**SUNDRY NOTICES AND REPORTS ON WELLS**  
*Do not use this form for proposals to drill or to re-enter an abandoned well. Use Form 3160-3 (APD) for such proposals.*

B.V. Lynch "A" Fed. #1

30-025-12550

**Permanent Abandonment of Federal Wells**  
**Conditions of Approval (LPC Habitat)**

Well Name: Bu Lynch A Fed 1

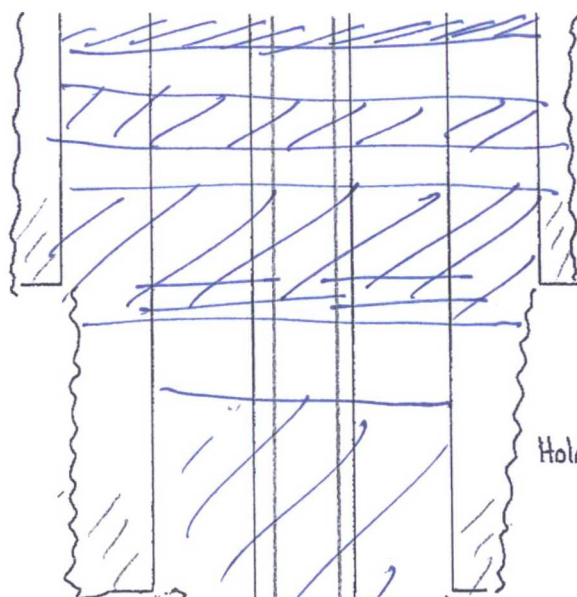
Perf + sqz =  
60-surf

Perf + sqz =  
400-300' TAG

Perf + sqz \* Add Plug  
? 1050-940'  
woc + tag

Perf + sqz Plug,  
from 3180-1700'  
woc + tag

CIBP 3535  
w 25 sx on top

Perf + Sqz Plug from 1050 - 940' woc + tag

Below ground Abandonment Marker Required (LPC)
